**ADDENDUM NO. 1**  
**May 21, 2026**  
**230693**

RE: **Charter Oaks Village Cooperative**  
**Arundel, ME**  
**Phase 1 Distribution Improvements**

FROM: DuBOIS & KING, INC.  
208 Union Avenue  
Laconia, NH 03246

SHEET NUMBER  
**C1**

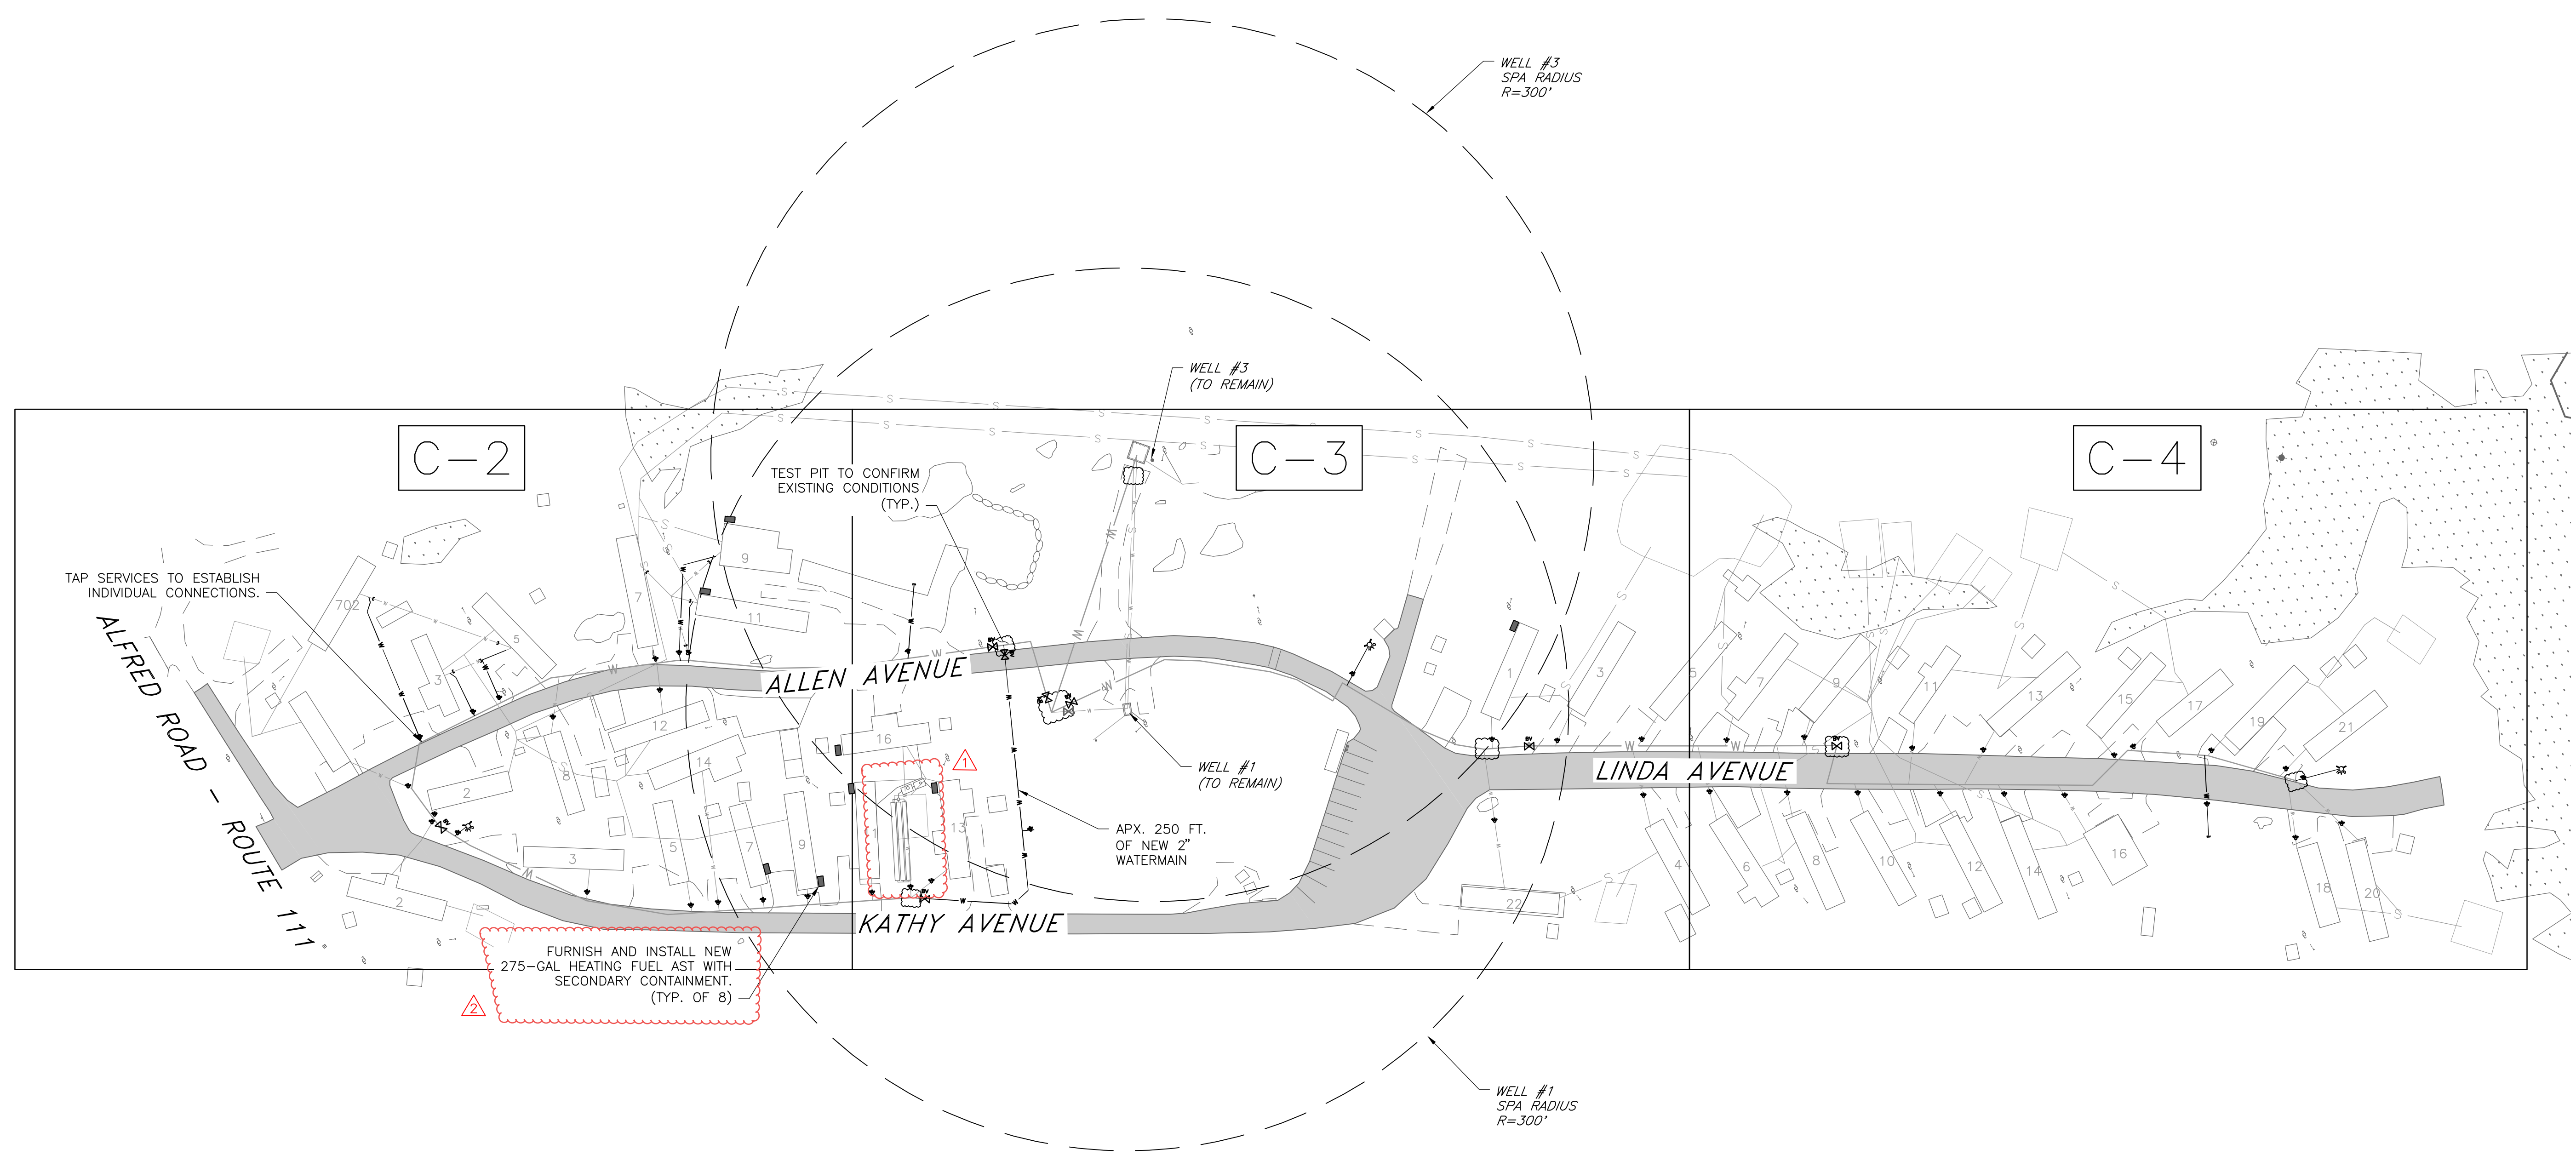
| REVISIONS | REVISION DESCRIPTION                                    | DATE               | NUMBER |
|-----------|---|--------------------|--------|
|           | ADD SEPTIC SYSTEM LOCATION<br>ADD SIZE OF FUEL OIL ASTS | 5/11/26<br>5/21/26 | 1<br>2 |

SHEET NUMBER  
**C2**

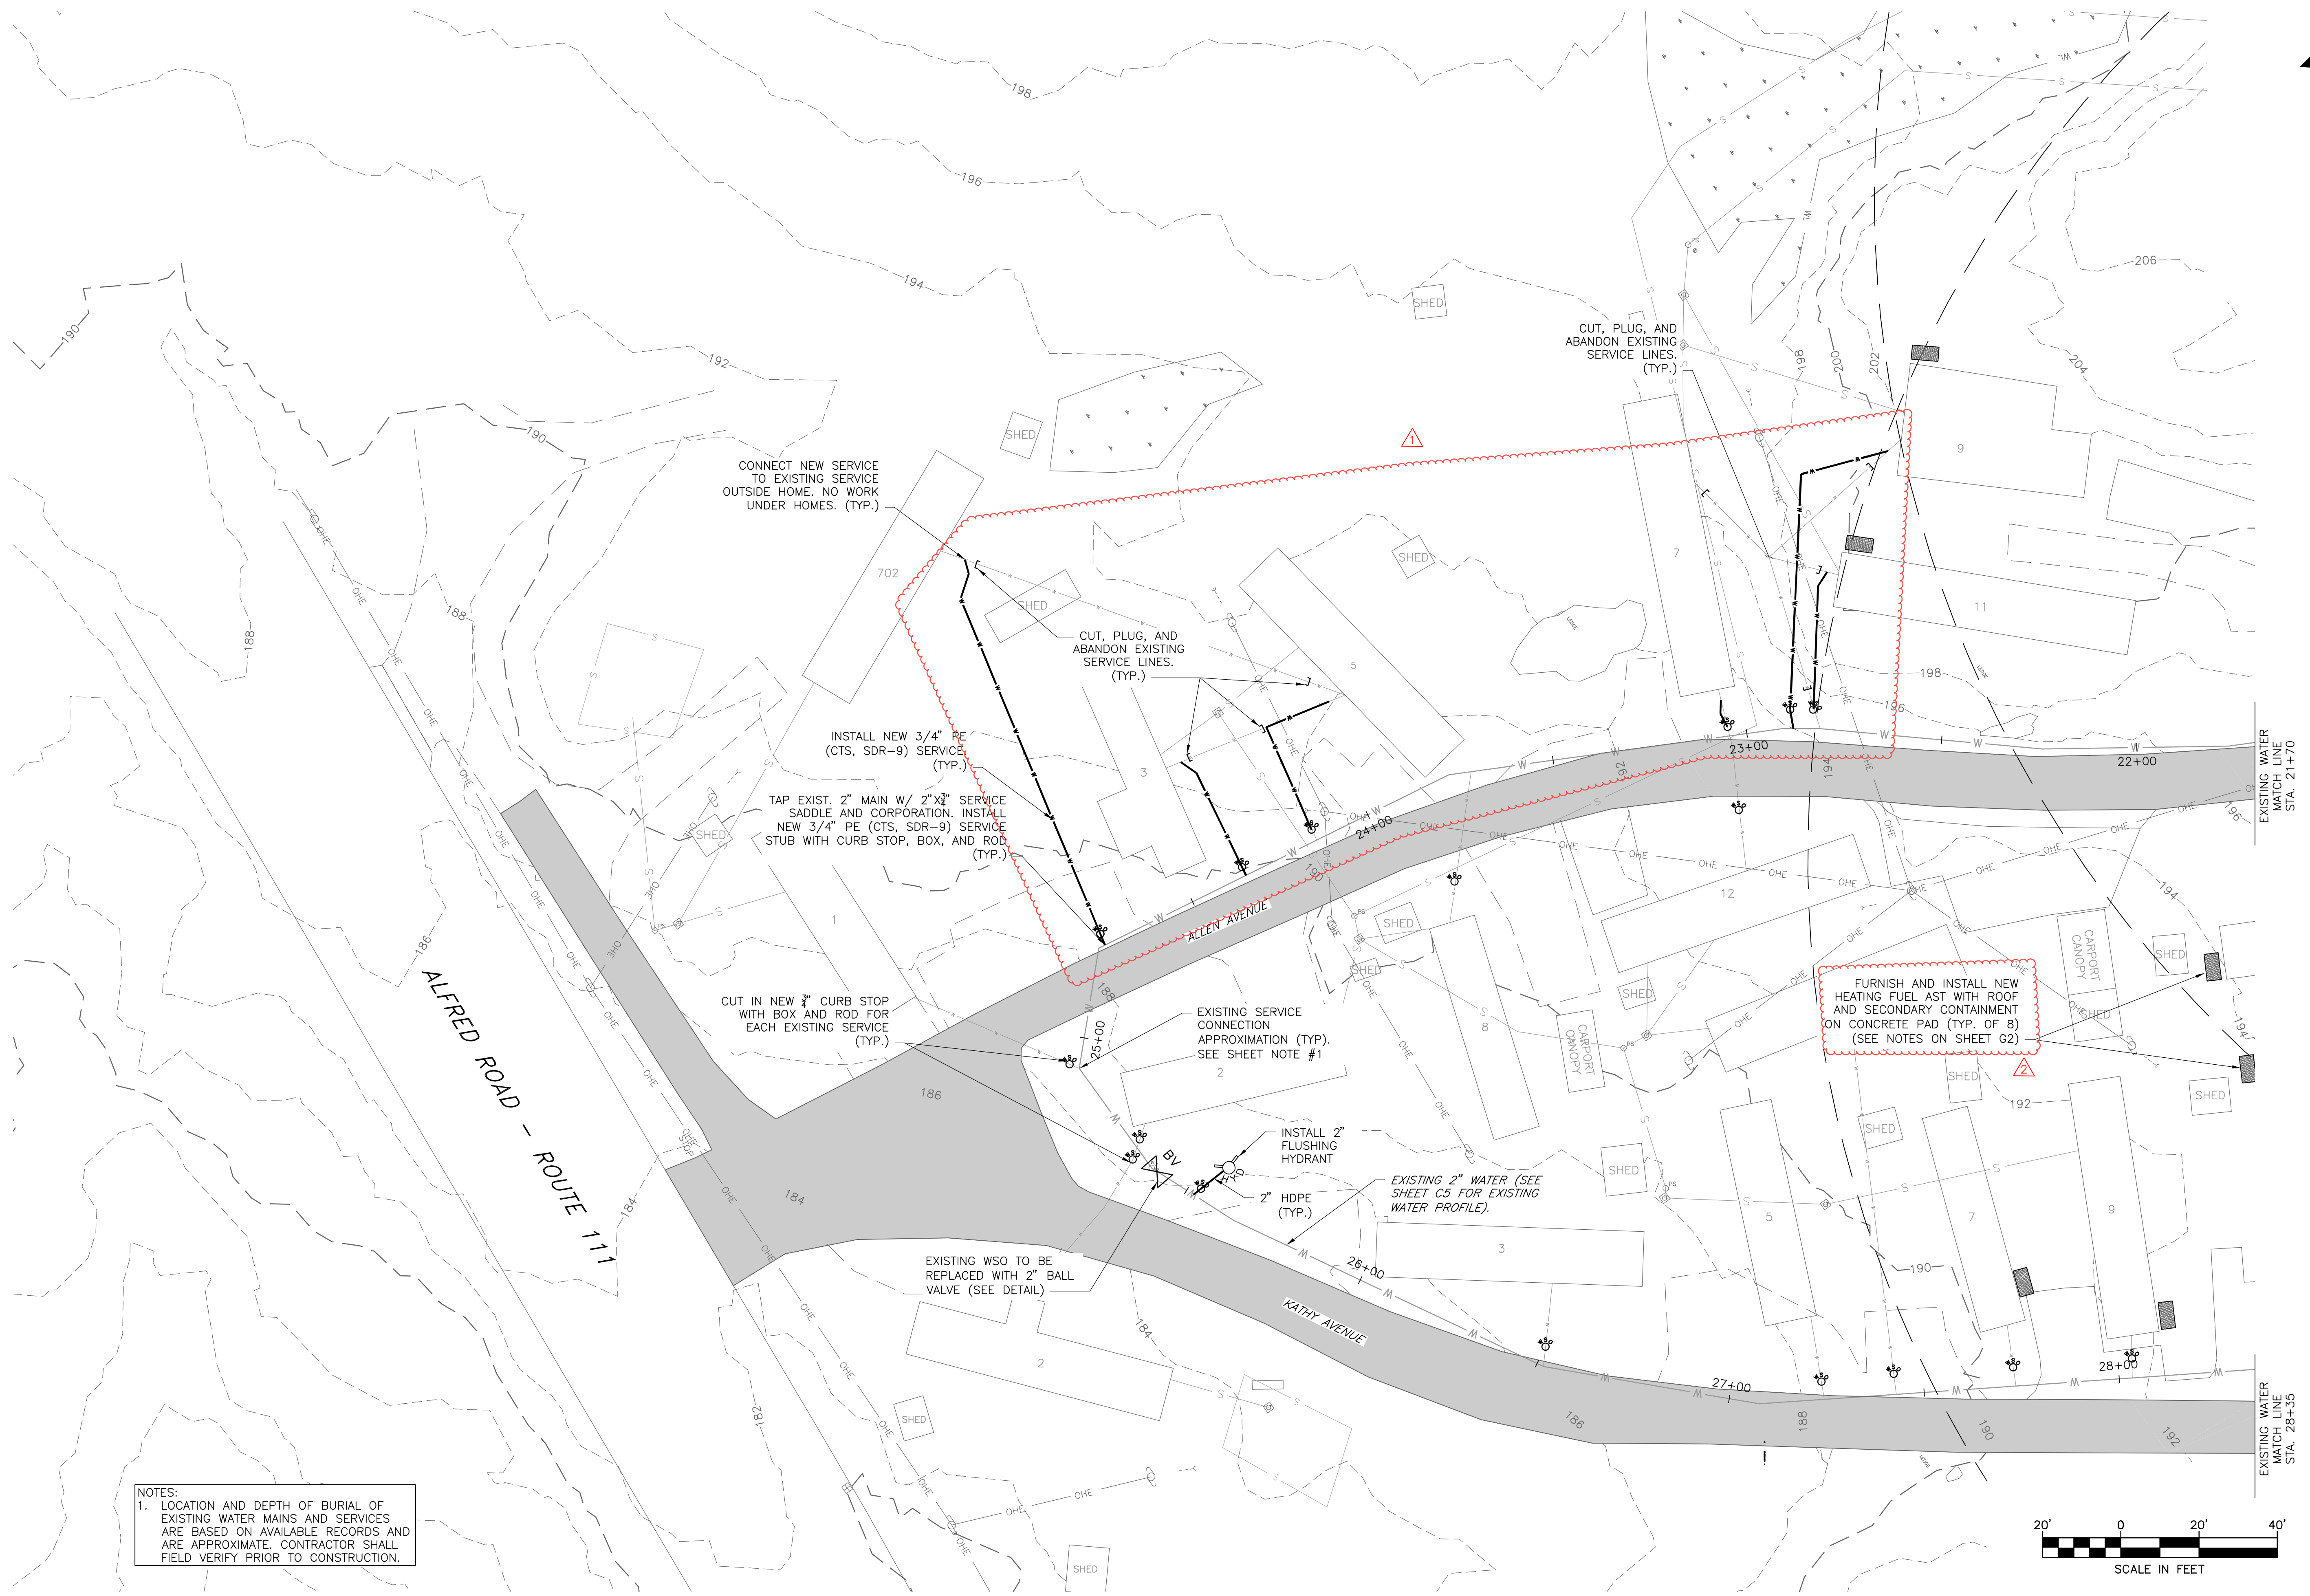
- New individual services were reconfigured to make it clear that no work is to be done under the home. (Sheet C2)
- A recently replaced septic system was added to the drawings as it is near a test pitting location and a connection point for the water main extension. (Sheets C3, C6)
- AST details were added to the plan set. (Sheet C10)

| REVISIONS | NUMBER | DATE    | REVISION DESCRIPTION   | BY  |
|-----------|--------|---------|------------------------|-----|
|           | 1      | 5/11/26 | REVISE SERVICES        | SAW |
|           | 2      | 5/21/26 | CLARIFY NUMBER OF ASTS | SAW |

**C3**

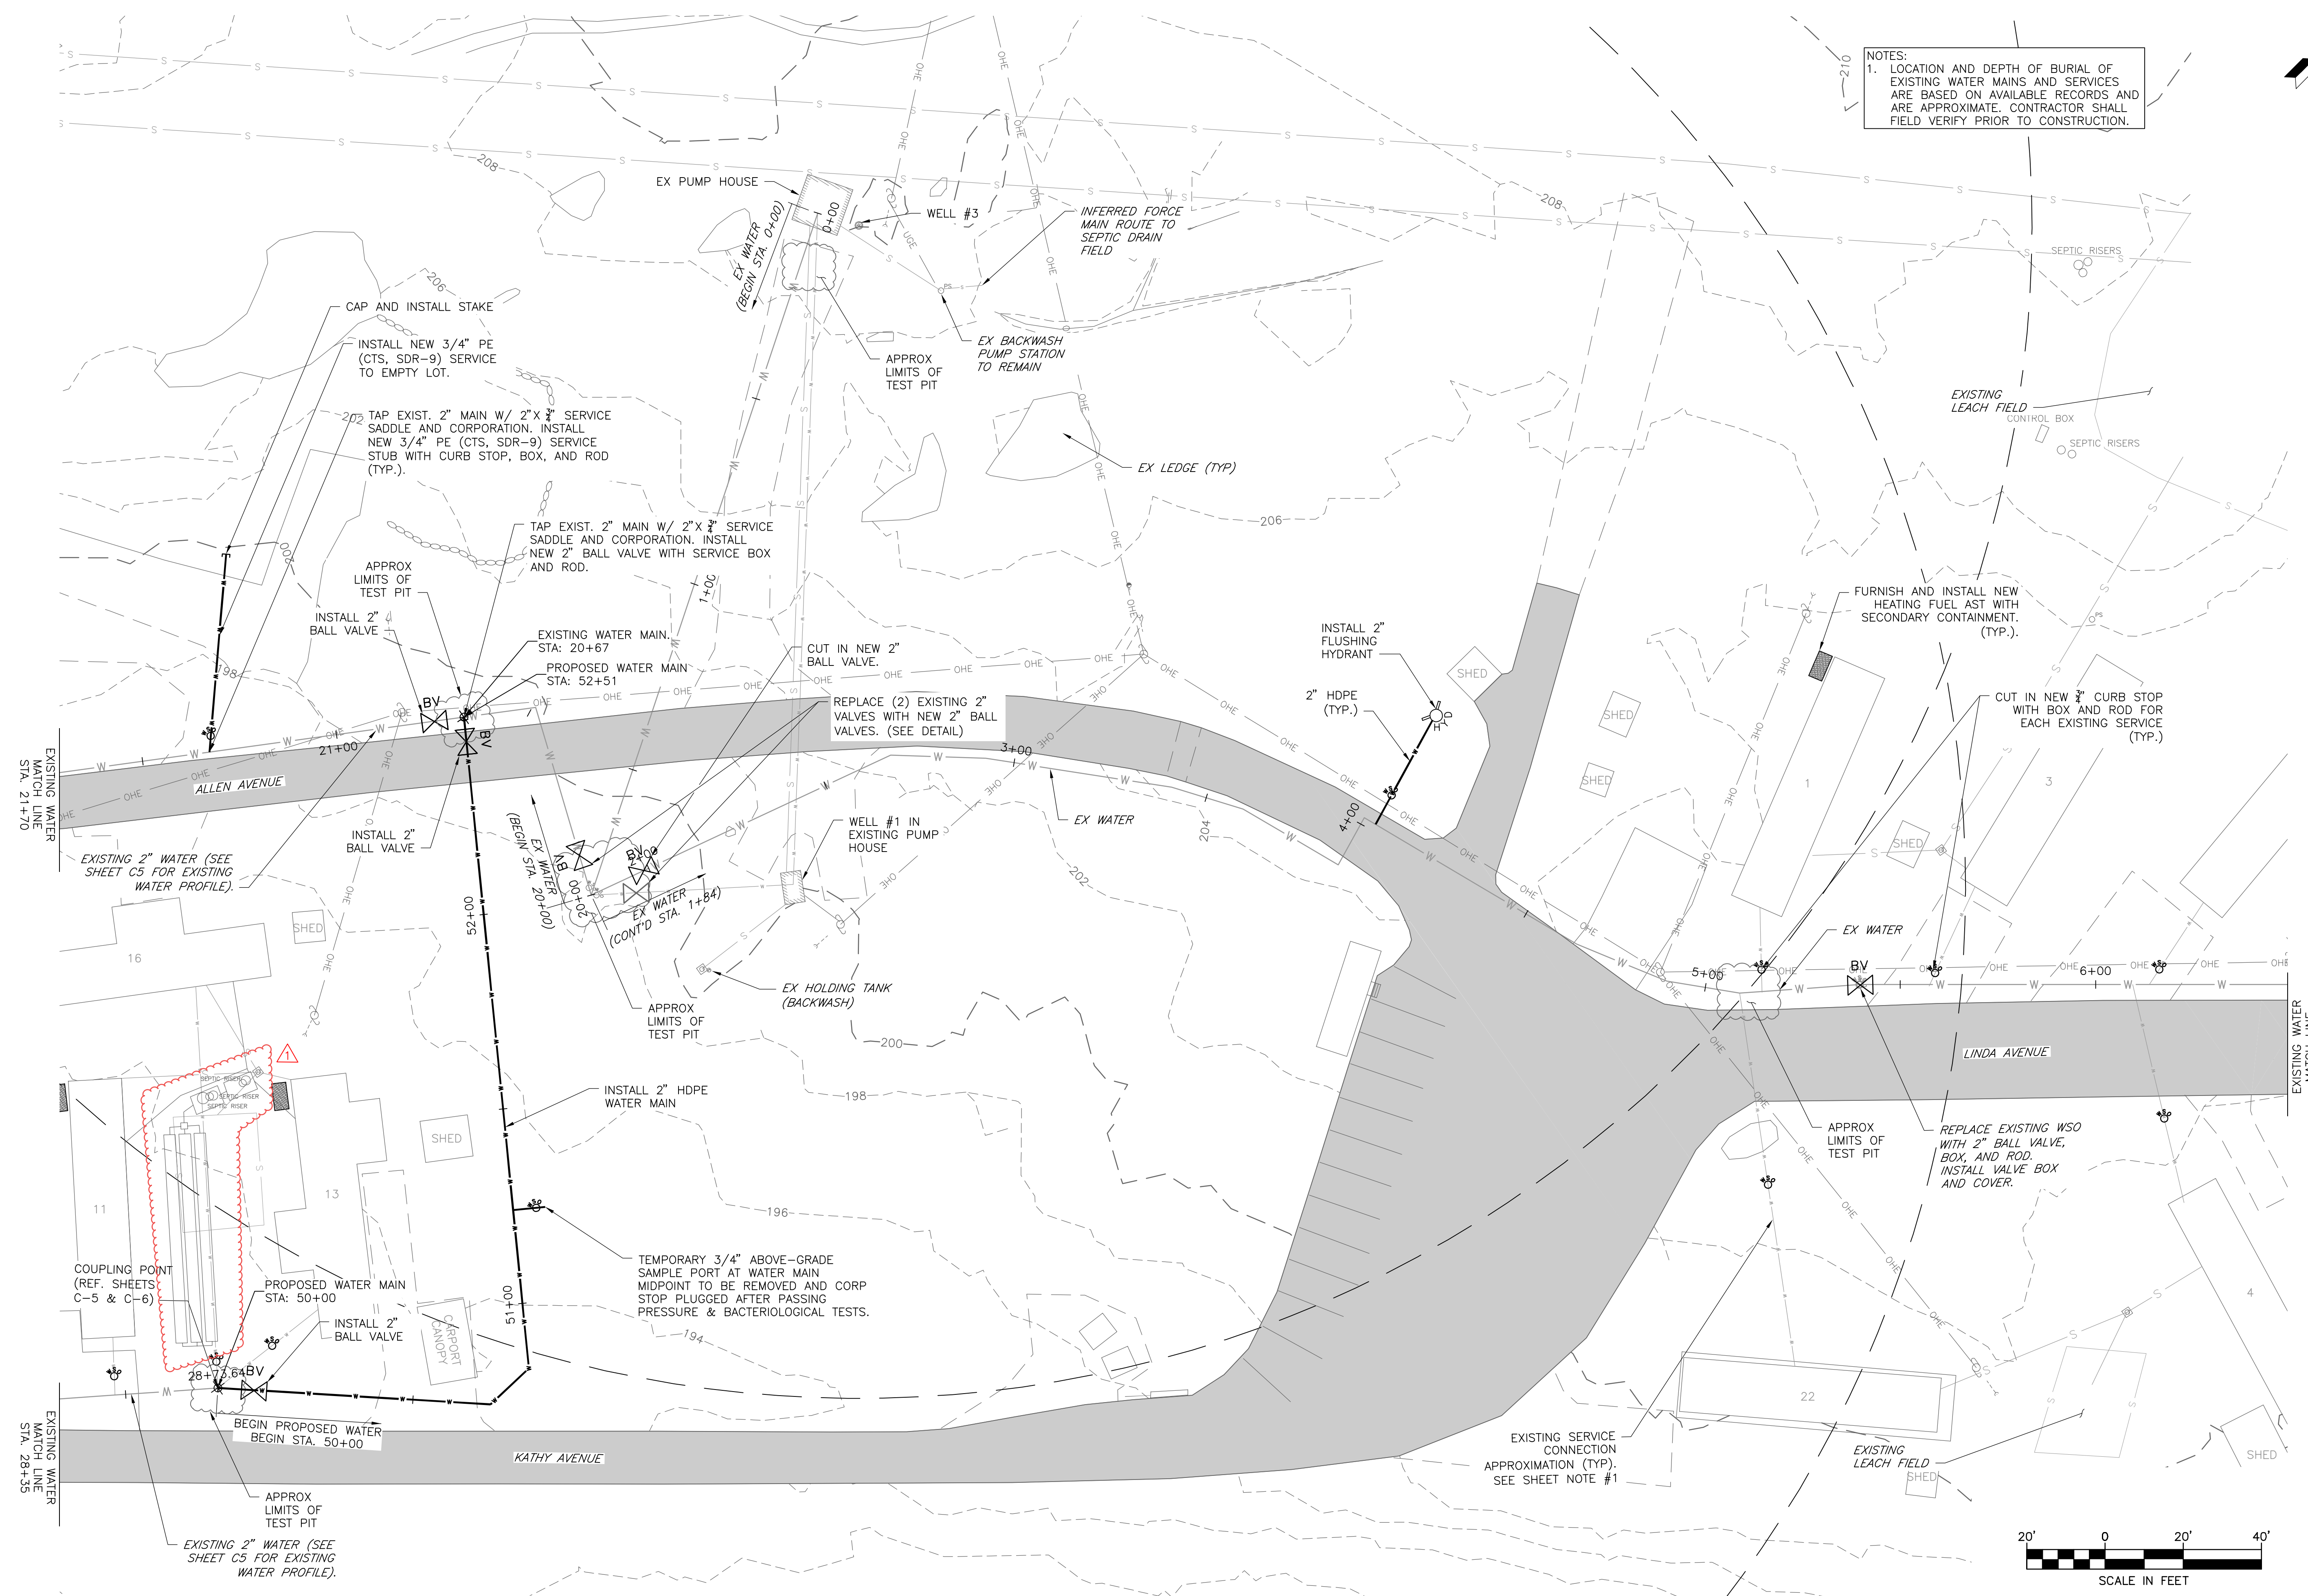
| REVISIONS | REVISION DESCRIPTION       | DATE    | BY  |
|-----------|----------------------------|---------|-----|
| 1         | ADD SEPTIC SYSTEM LOCATION | 5/11/26 | SAW |
